VSH PREMIER CIRCLE ARB 2022-29

SUBMISSION OF FINAL SITE PLAN

May 8, 2023

VSH PREMIER CIRCLE - ARB 2022-29

JOB NO.: 46555
SHEET NO.: C4.0

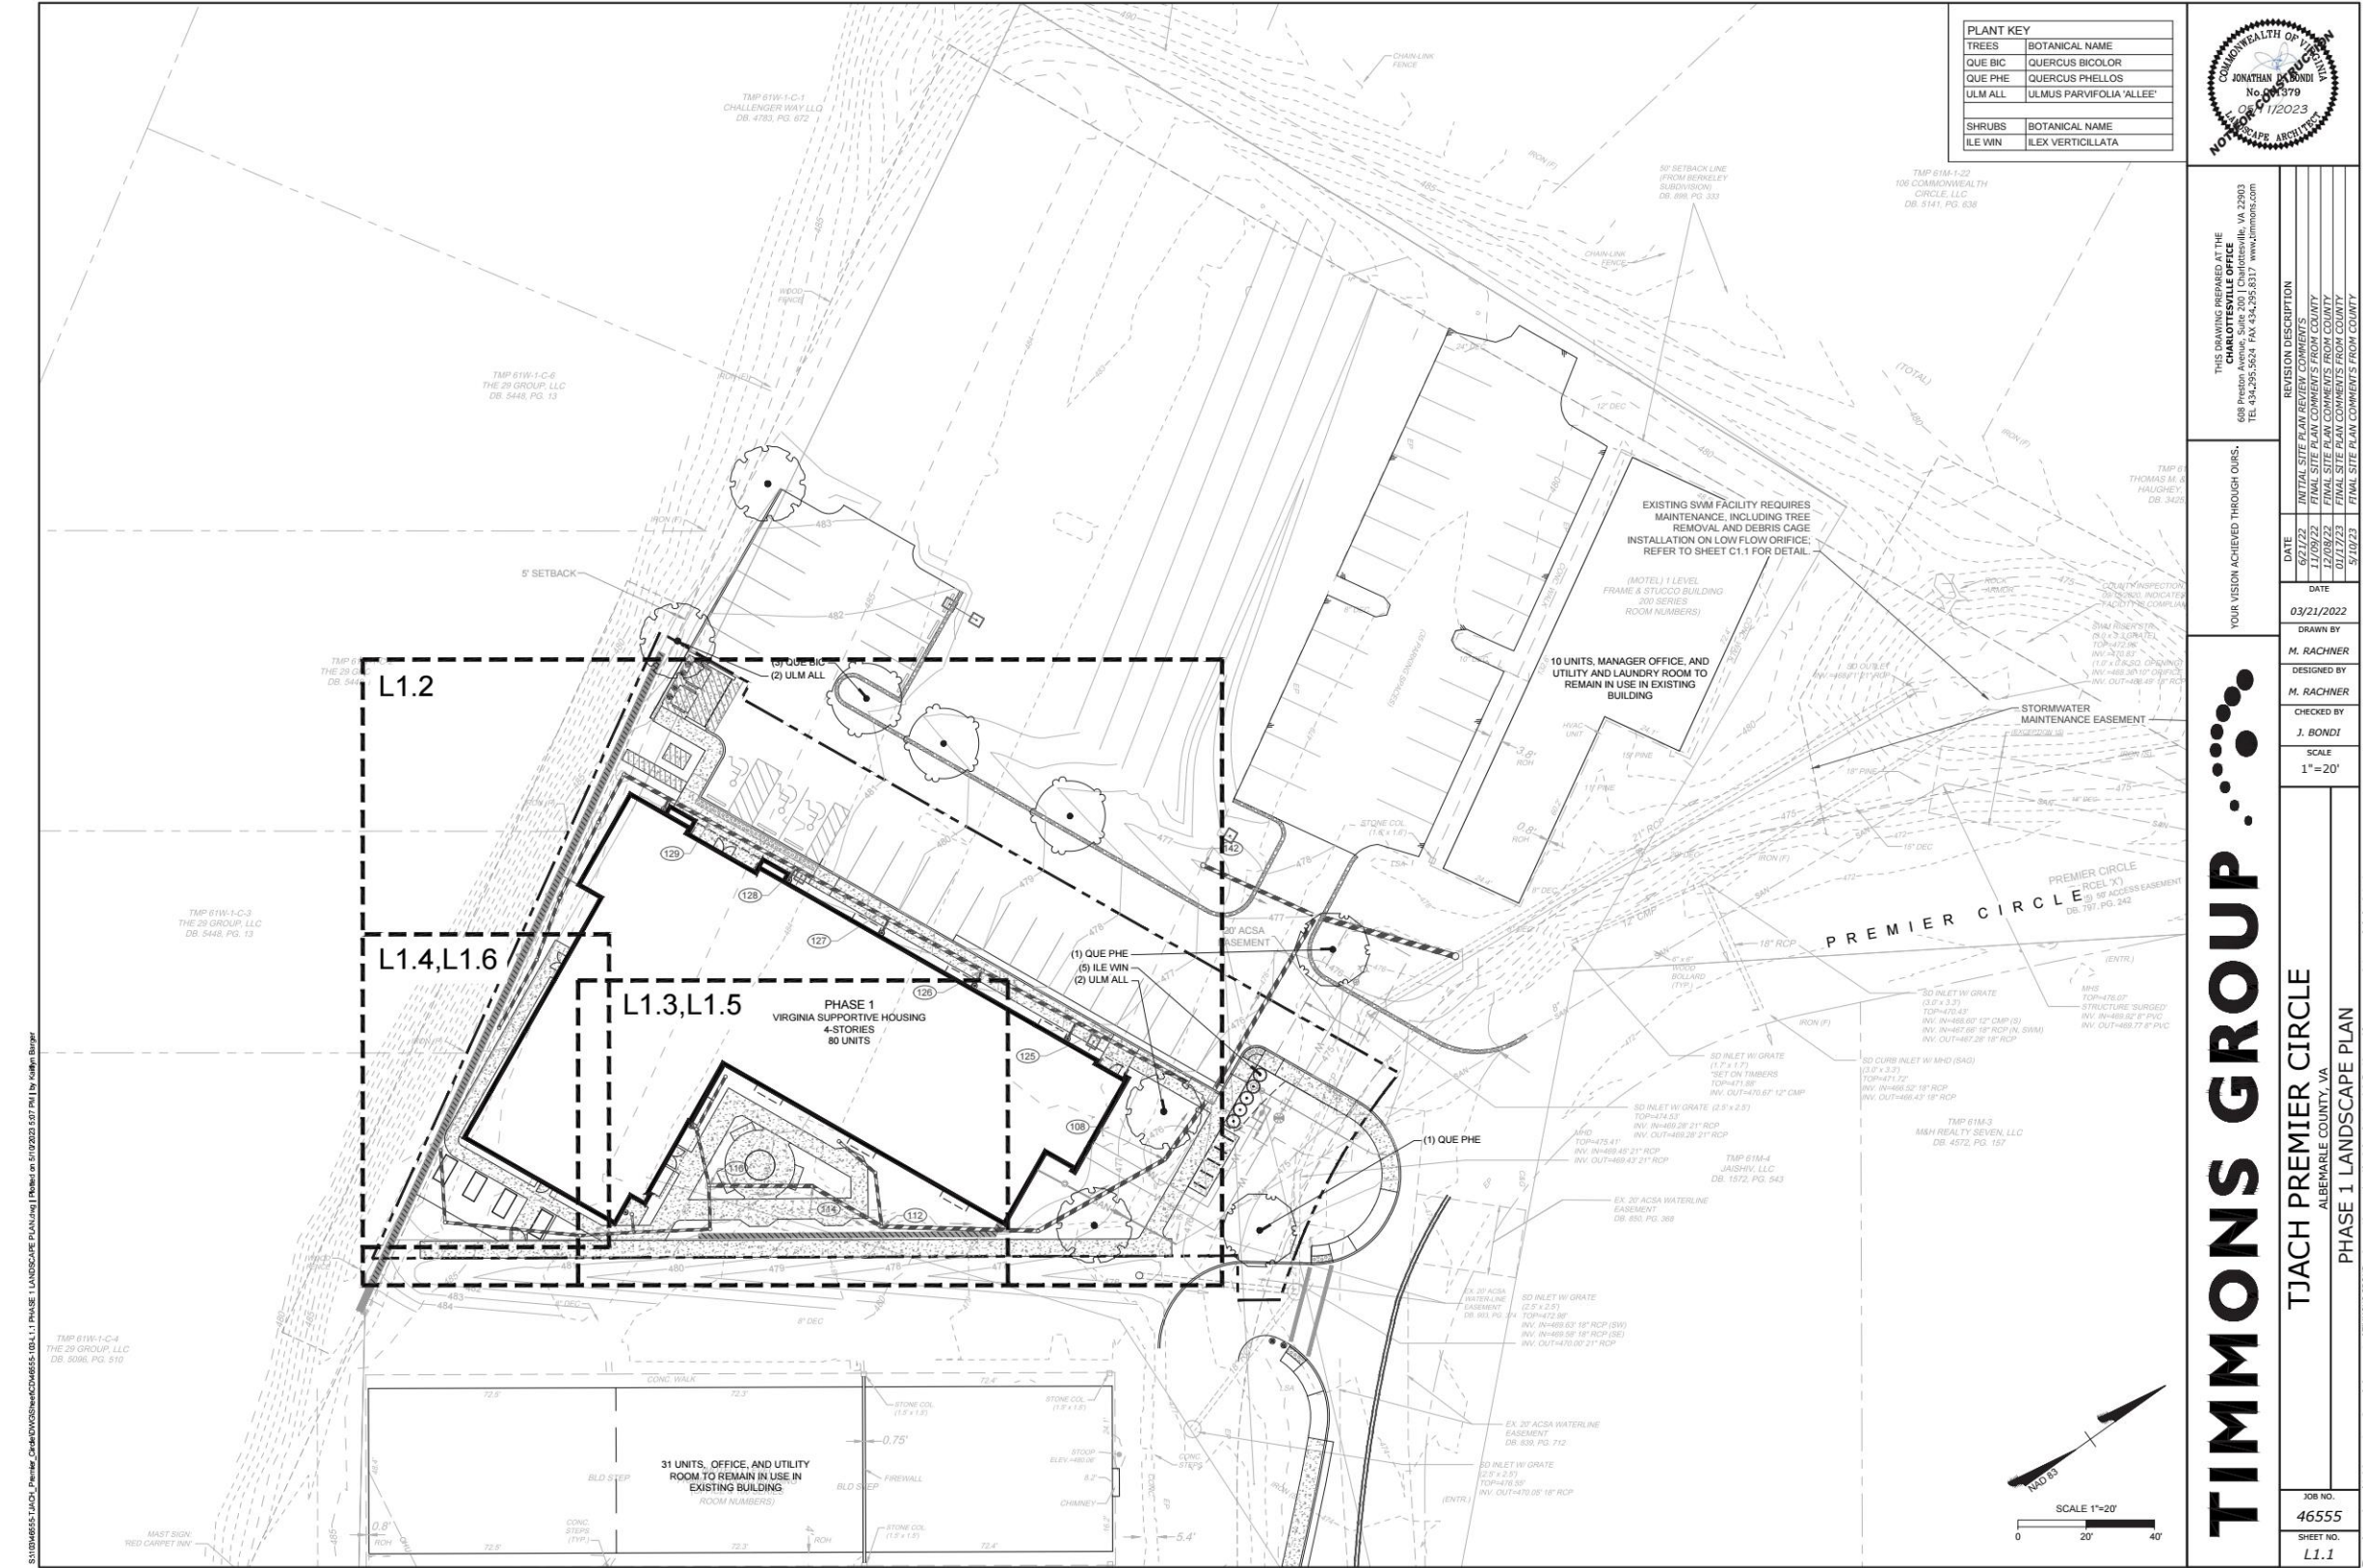
- ### RESPONSE TO COMMENTS
5. Revise the site plan set to include the limits of work for each phase of the development
- This Final Site Plan is being submitted with for this first phase of construction. Future phases will have Final Site Plans for those phases. See Final Site Plan.
15. Revise the site plan to show the limits of work for Phase 1 of the development. Show tree protection fencing on, and coordinated throughout, the grading, landscaping, and erosion and sediment control plans where needed.
- Site plan revised to show limits of work for phase 1. See Final Site Plan.

JOB NO.	46555
SHEET NO.	L1.2

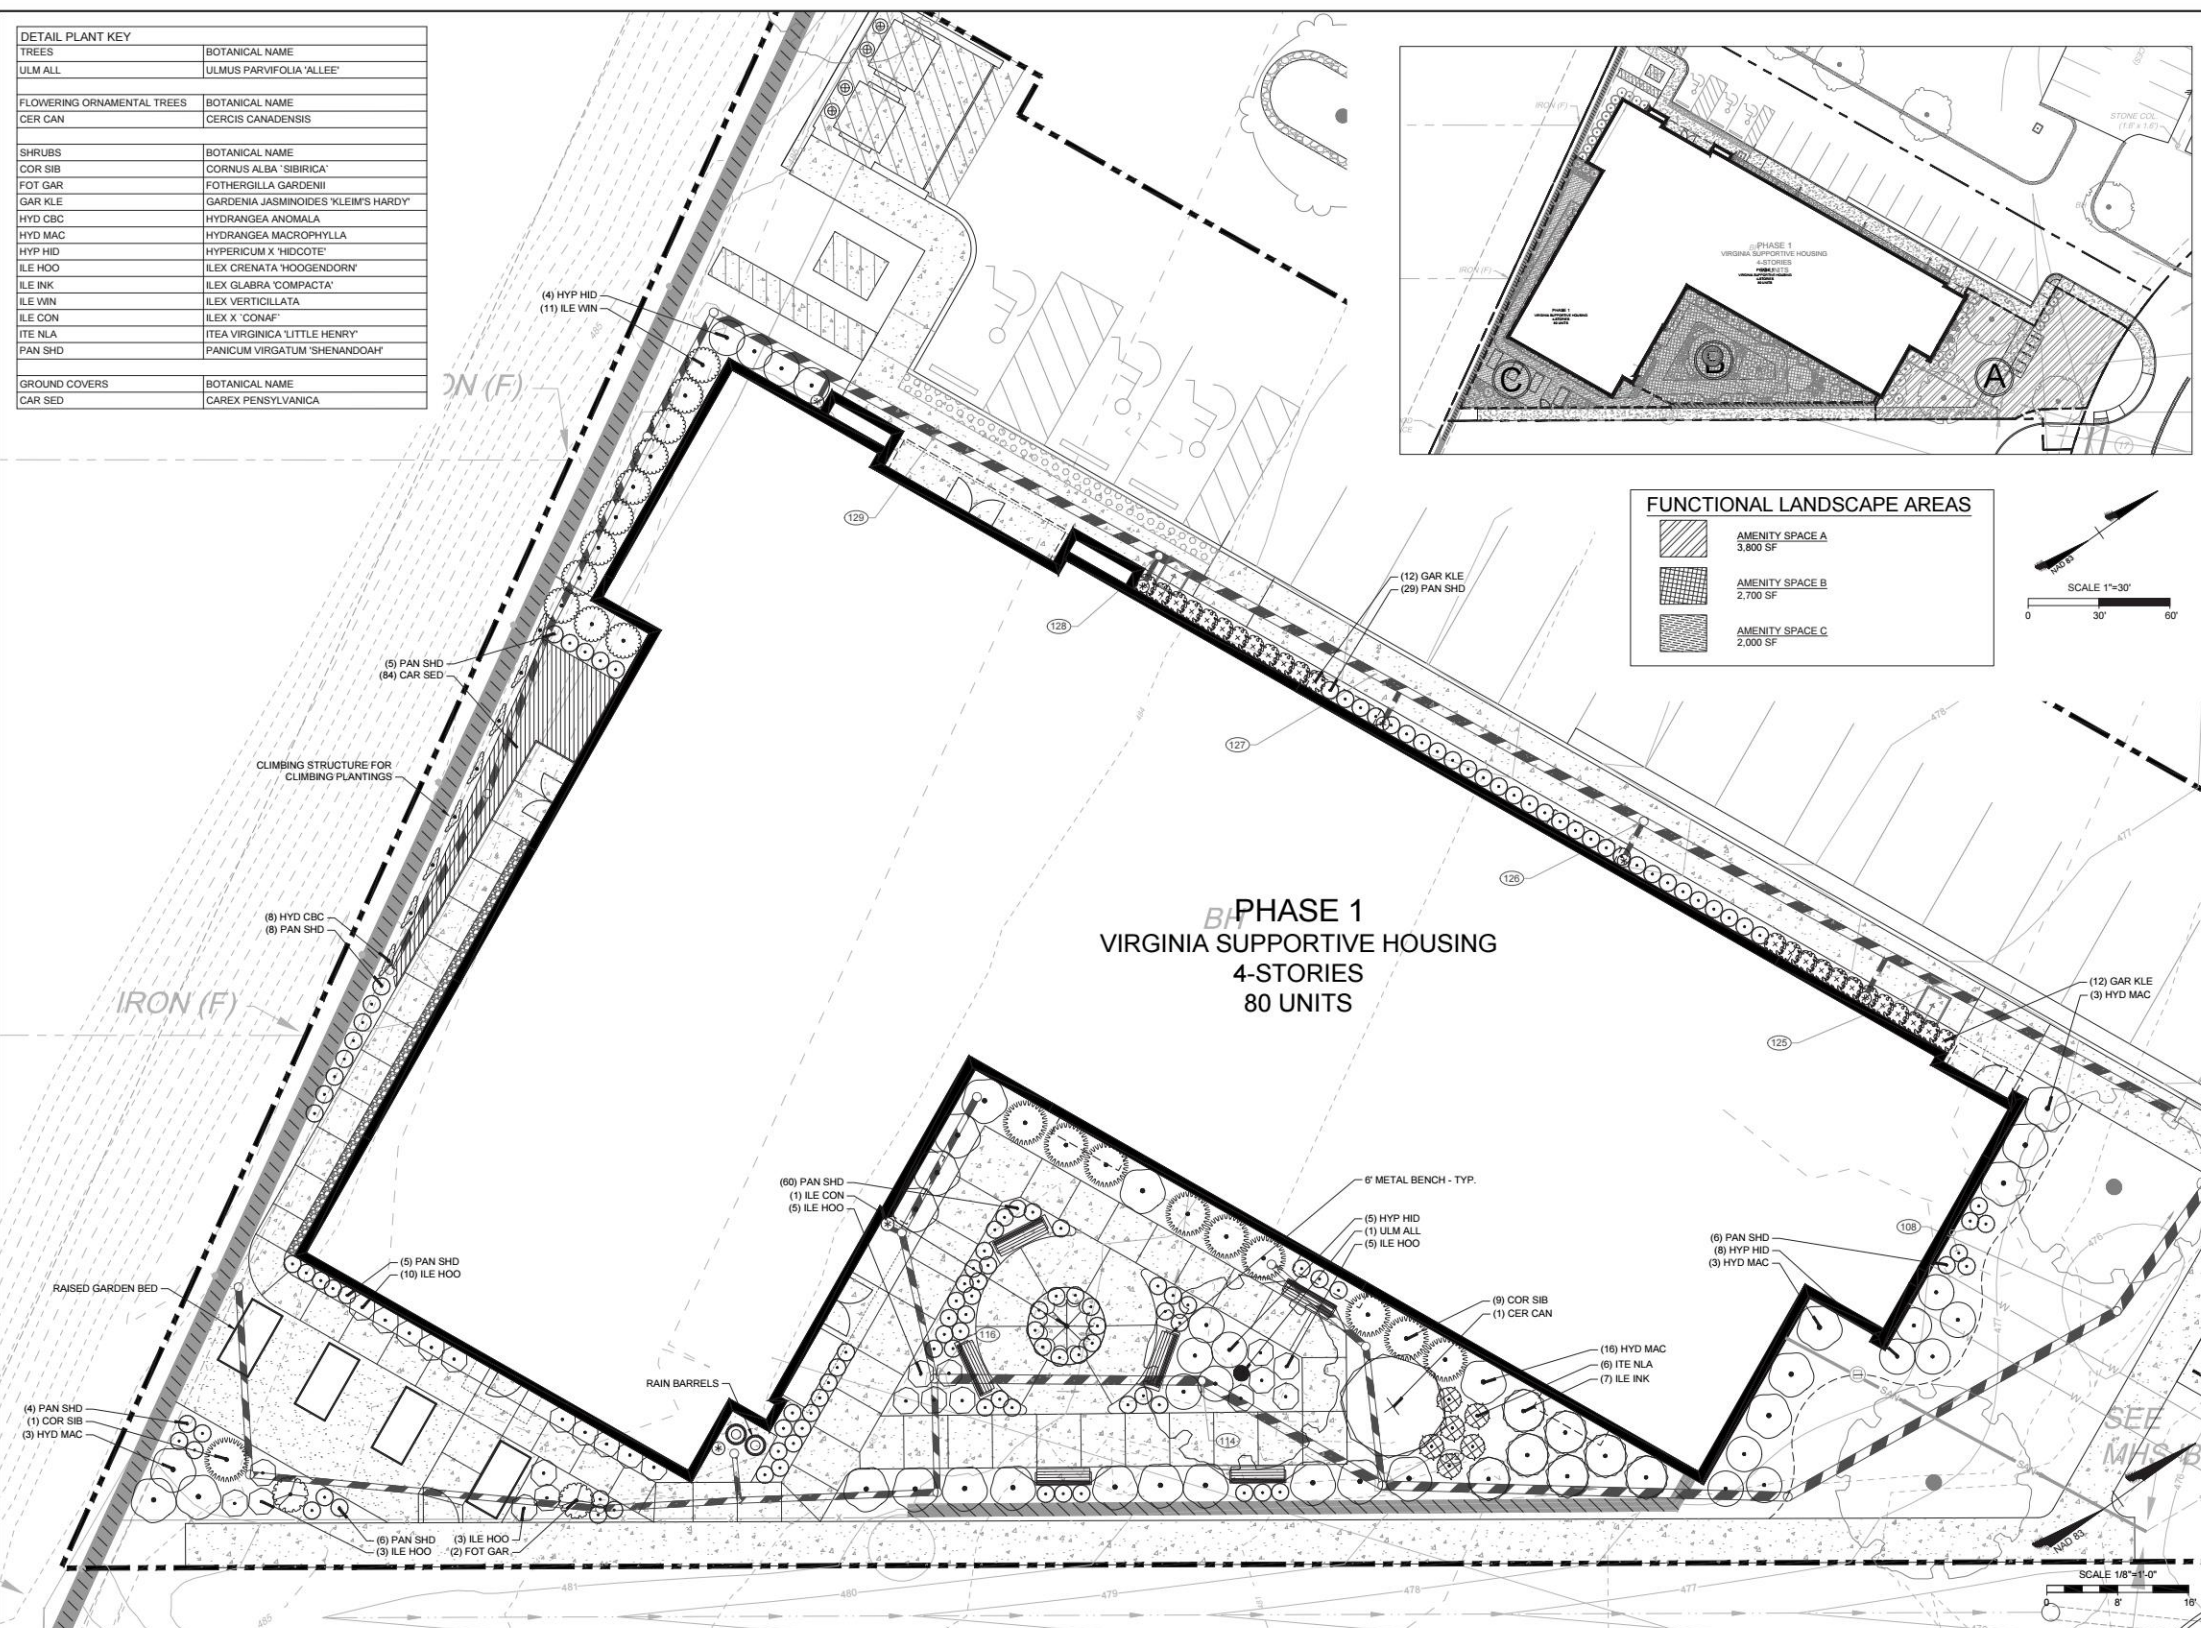
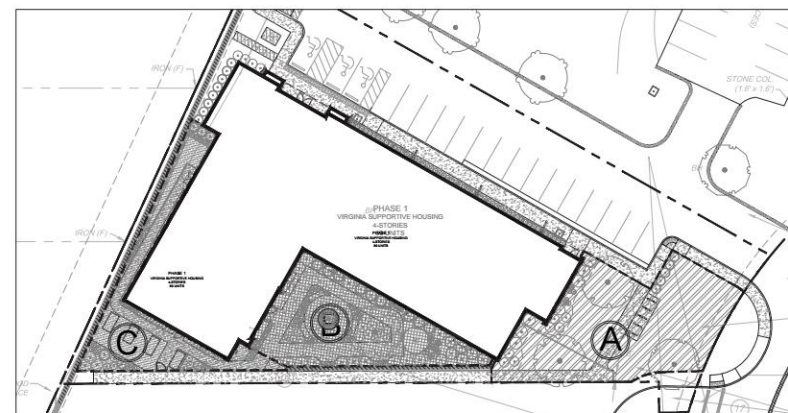
14. Revise the landscape plan to provide additional trees to meet the interior parking area landscaping requirements (one tree for every 10 spaces evenly distributed)

Landscape plan revised. Proposed trees meet the landscaping requirements and are located in such a way that they will not be affected by later phases. See Final Site Plan.

PERSPECTIVE - LOOKING SOUTH FROM RT.29

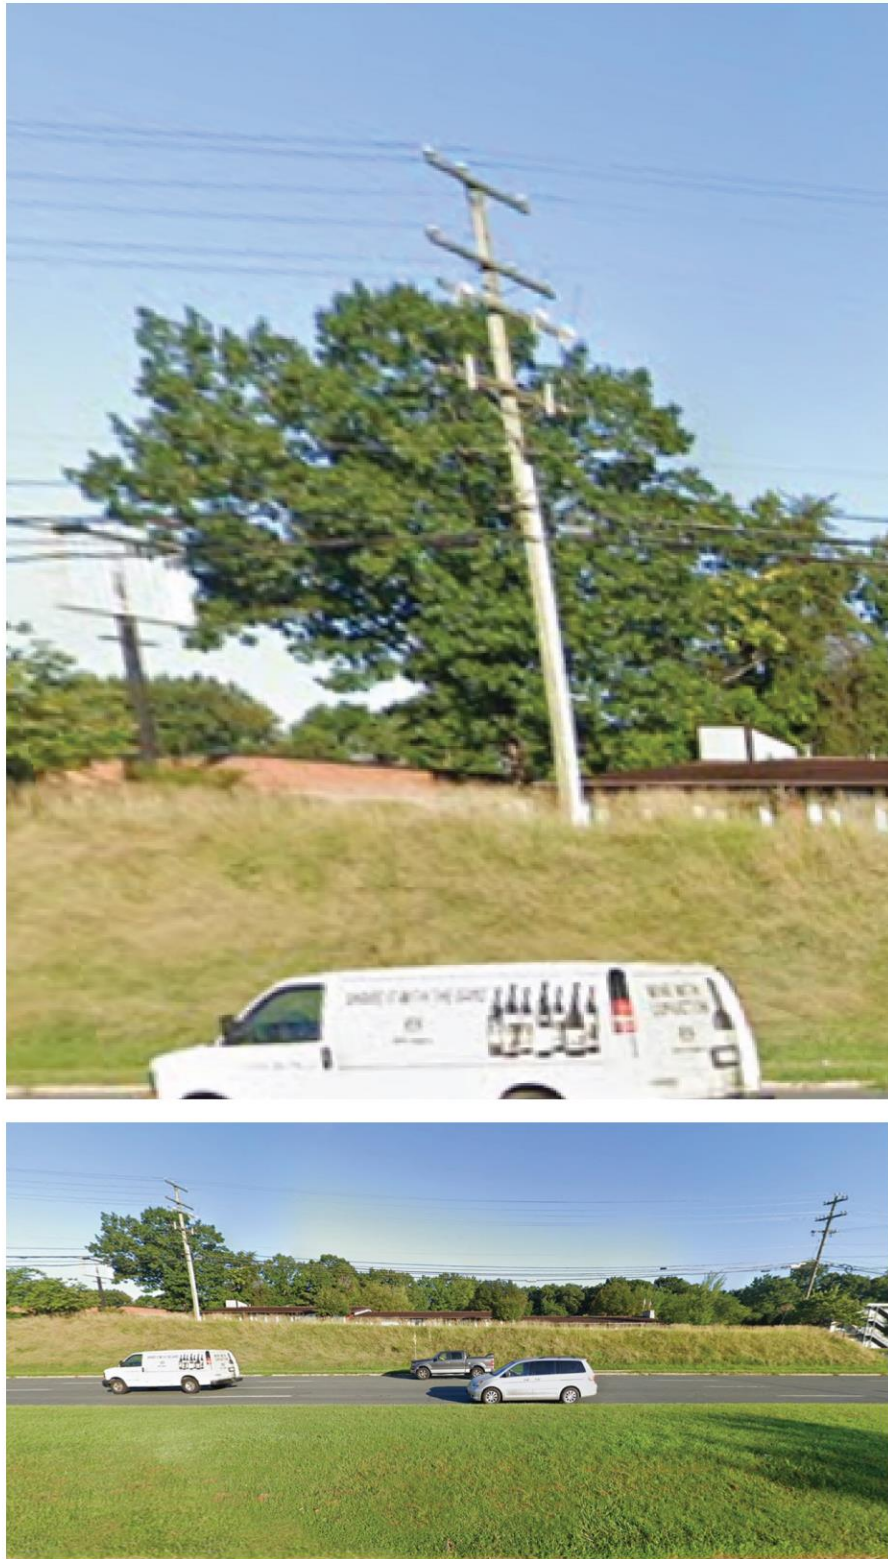
2.
Consider revising the windows along the south elevation, west of the courtyard area to match the scale of the windows present in the overall building design or otherwise relieve the blankness.

3.
Consider revising the design of the southern portion of the east elevation to add architectural details to relieve the blankness.

9.
Add the standard mechanical equipment note to the architectural plans: "Visibility of all mechanical equipment from the Entrance Corridor shall be eliminated." See note below.

To provide windows along this façade to provide a consistent look is not possible as windows at a consistent head height will interfere with the interior layout, which have kitchens along this location. The building has been revised to include windows on the north facade, east of the stair as indicated in the perspective rendering to the left.

To provide windows along this façade to provide a consistent look is not possible as windows at a consistent head height will interfere with the stair landings on the interior. The building has been revised to include windows on the north facade, east of the stair as indicated in the perspective rendering to the left.

NOTE:
VISIBILITY OF ALL MECHANICAL EQUIPMENT FROM THE ENTRANCE CORRIDOR SHALL BE ELIMINATED
